A Planning Application by
COMPLETE PLANT HIRE LIMITED

In respect of
**12 Southfields,
WELWYN GARDEN CITY**

Technical Note – Survey Summary

August 2021

Figure 2.1 Survey Plan

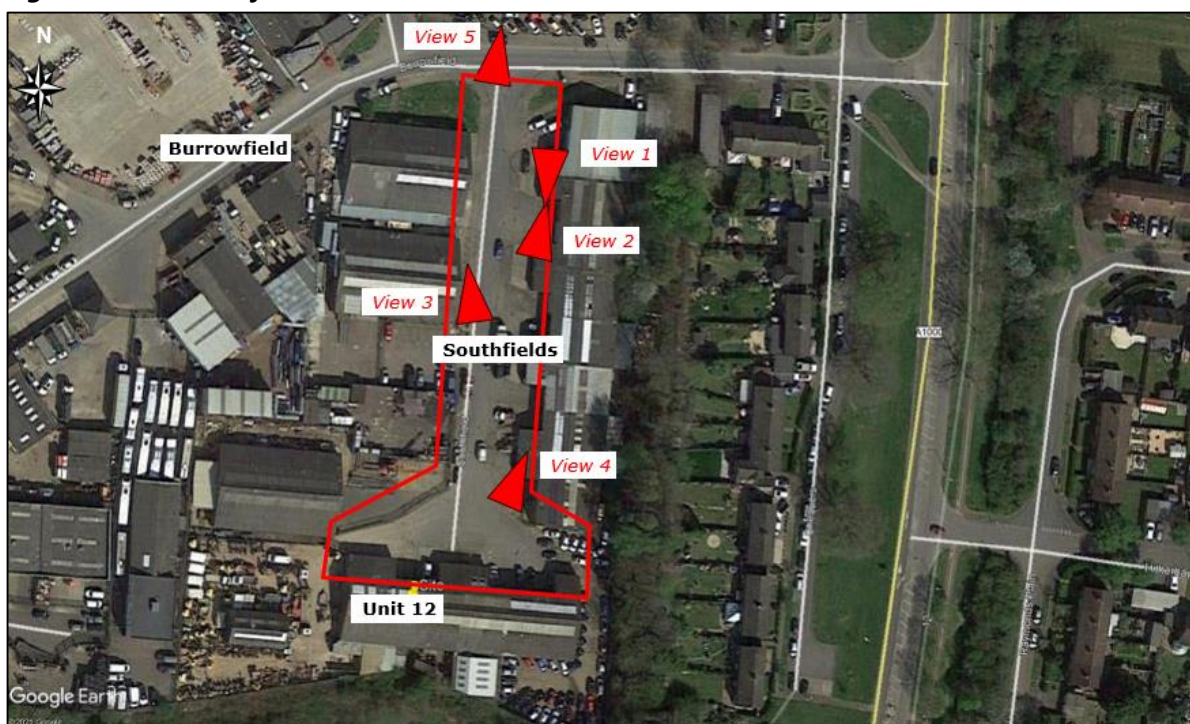
“Evidence of the arrival and departure profile has not been provided by the applicant, and also the types of vehicle have not been detailed in the arrival / departure profile. These details must be provided by the applicant in order to demonstrate and evidence the site operator’s trip attraction.”

The details provided state that the site attracts 30-40 vehicles per day, i.e. 80 two-way vehicle trips. Evidence of the arrival and departure profile has not been provided by the applicant, and also the types of vehicle have not been detailed in the arrival / departure profile. These details must be provided by the applicant in order to demonstrate and evidence the site operator's trip attraction.

2.2 To allow for a daily arrival and departure profile to be prepared, a survey was undertaken by Advanced Transport Research between Tuesday 20 July 2021 and Thursday 22 July 2021, by CCTV. The survey covered the 12 hour period between 07:00 and 19:00. The resulting survey data is contained within **Appendix B** and a plan illustrating the camera locations and survey extents is set out in **Figure 2.1**.

Figure 2.3 Personal Injury Collision Data

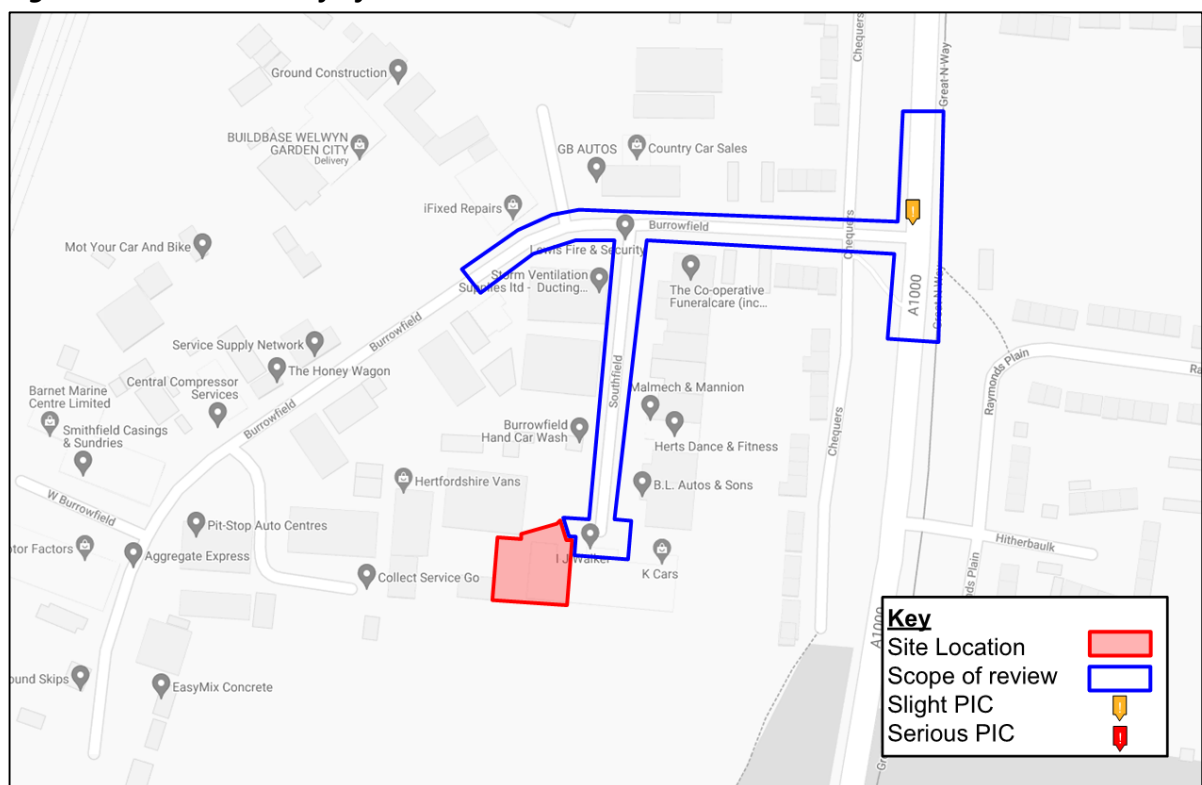
“Review of personal injury collisions on the local highway network over the most recently available five years of data.”

The Transport Technical Note has not included a review of personal injury collisions that have occurred on the local highway network over the most recently available five-year period of data. The Highway Authority request this is undertaken, and details of patterns/clusters of collisions must be provided.

2.17 Accordingly, a review of the personal injury collision (PIC) record for the local highway network has been undertaken, based on the most recent five years of data obtained from Crashmap. The data, summarised in **Figure 2.3**, shows that only one slight PIC has been recorded in the five year period between 2016-2020. As can be seen, this incident took place on the A1000 close to the junction with Burrowfield and at some remove from the site.

- 2.18 A single PIC within the last 5-year period does not indicate that there is any significant highway safety issue in the vicinity of the site. It is also the case that the current use of the site has been in operation for 5 years and it is understood that the PIC identified did not involve a vehicle associated with Complete Plant Hire Ltd.

TITLE:
**SWEPT PATH ANALYSIS OF
 A 26t RIGID VEHICLE**

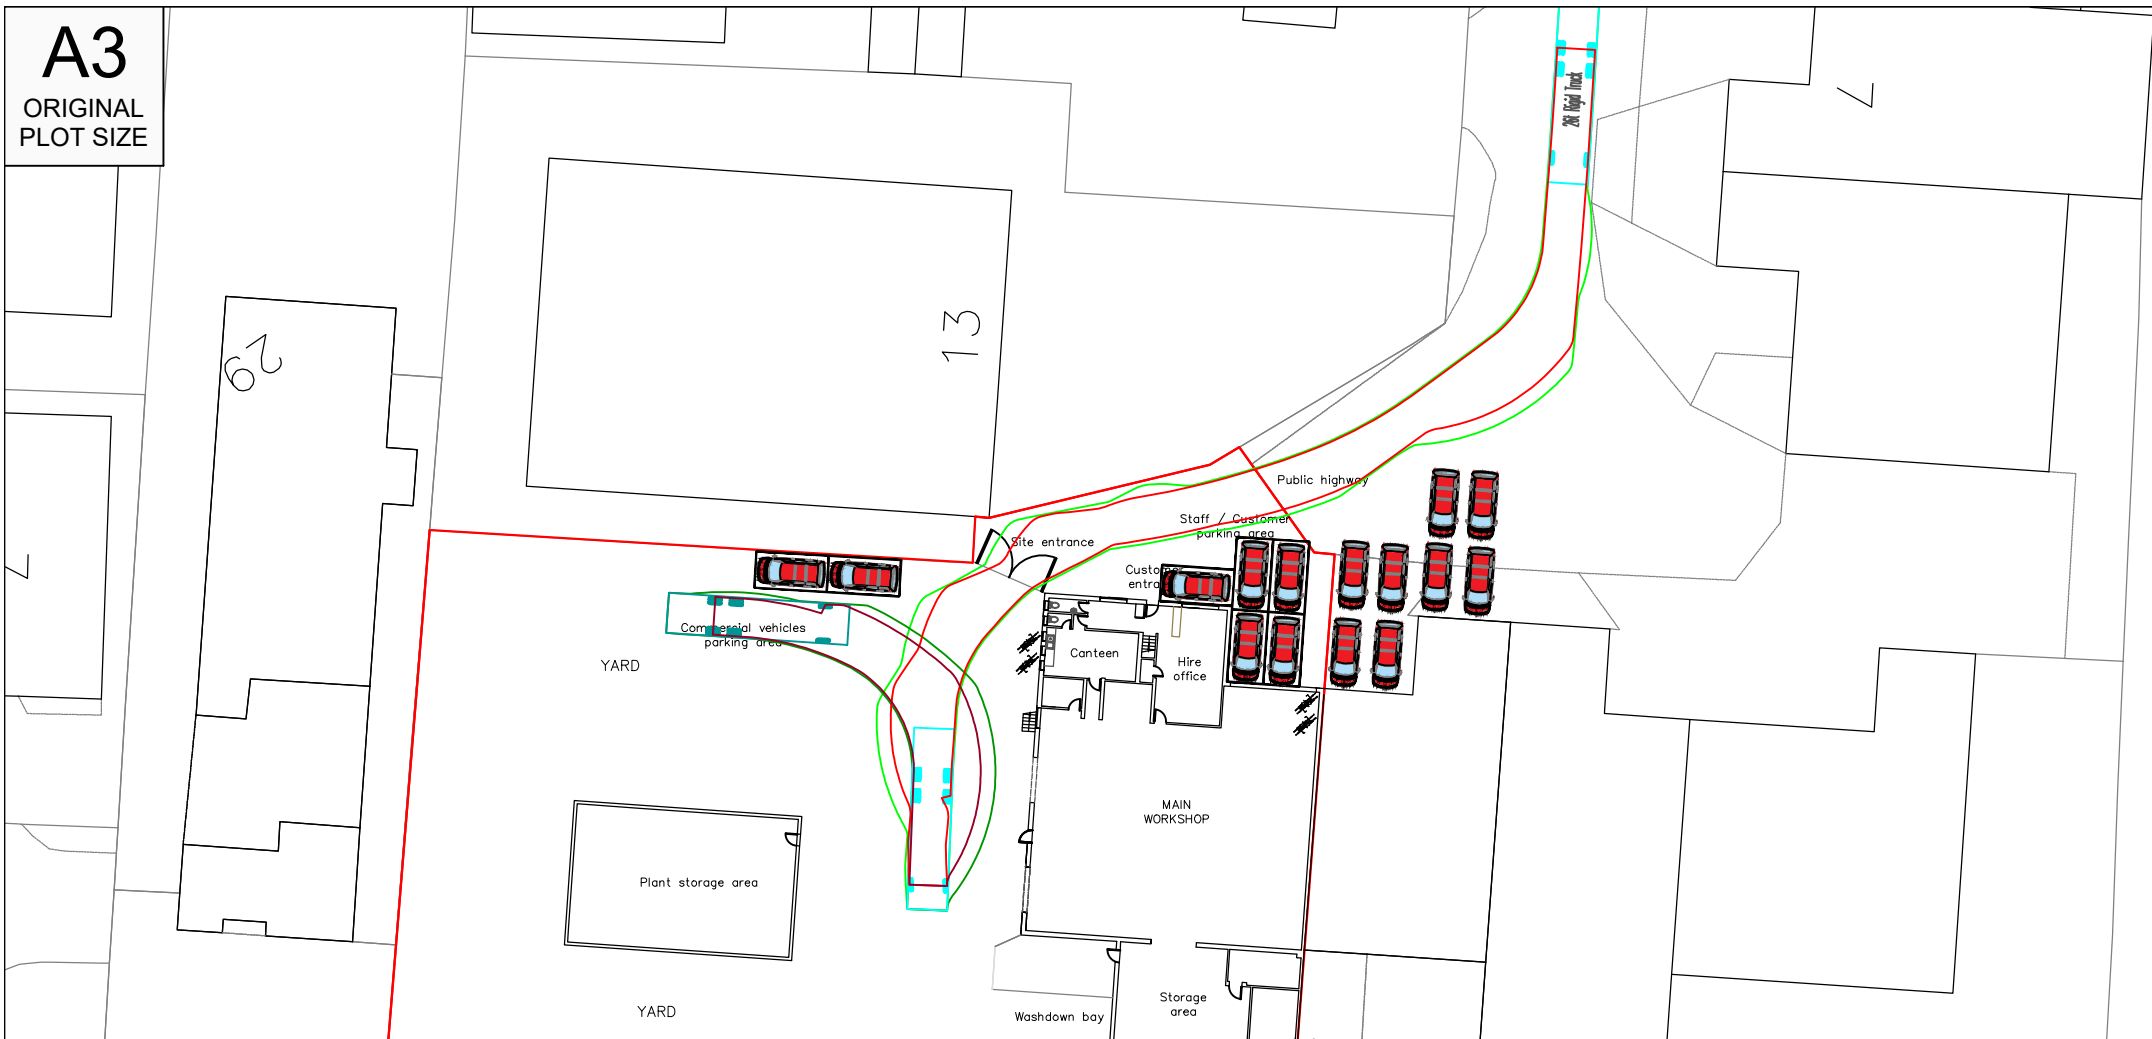
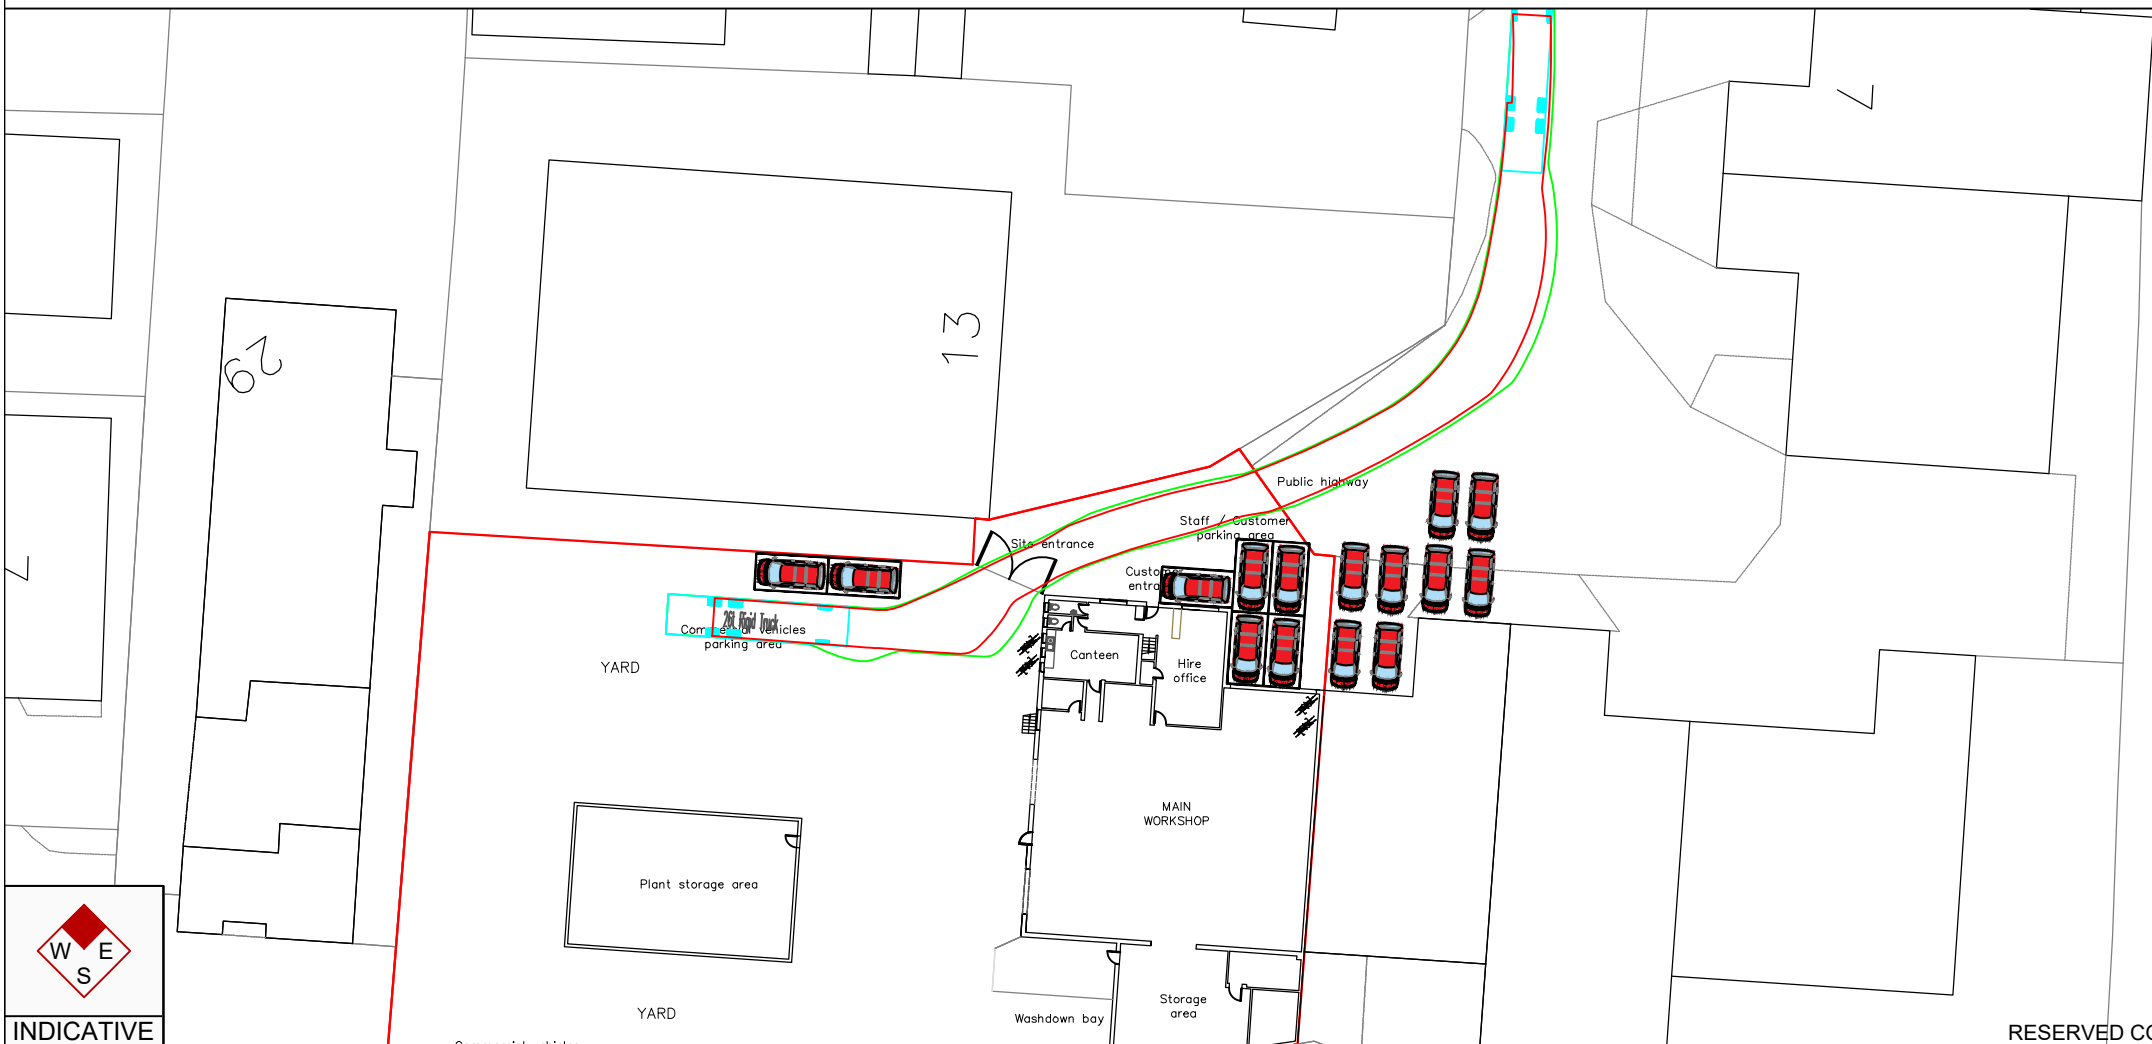
“The Highway Authority are concerned that the Transport Technical Note contained only limited details of the types of vehicle that access the site and therefore the swept path shown in Drawing No. SP01 may not representative of the largest vehicle that will commonly use the site (i.e. lengths of low loaders and articulated vehicles). Without these details there is a highway safety risk that large vehicles may reverse long distances on the public highway.”

The Highway Authority are concerned that the Transport Technical Note contained only limited details of the types of vehicle that access the site and therefore the swept path shown in Drawing No. SP01 may not be representative of the largest vehicle that will commonly use the site (i.e. lengths of low loaders and articulated vehicles). Without these details there is a highway safety risk that large vehicles may reverse long distances on the public highway.

- 3 x Box Vans - 6.5m x 2.1m;
- 1 x 26 tonne rigid trucks - 12m x 2.55m; and
- 2 x pick-up trucks - 6.6m x 2.1m.

2.10 A swept path analysis of a 26 tonne vehicle has been undertaken and is contained within **Appendix C**. As can be seen, the vehicle can enter and exit the site in forward gear. This manoeuvre can be seen in the CCTV survey.
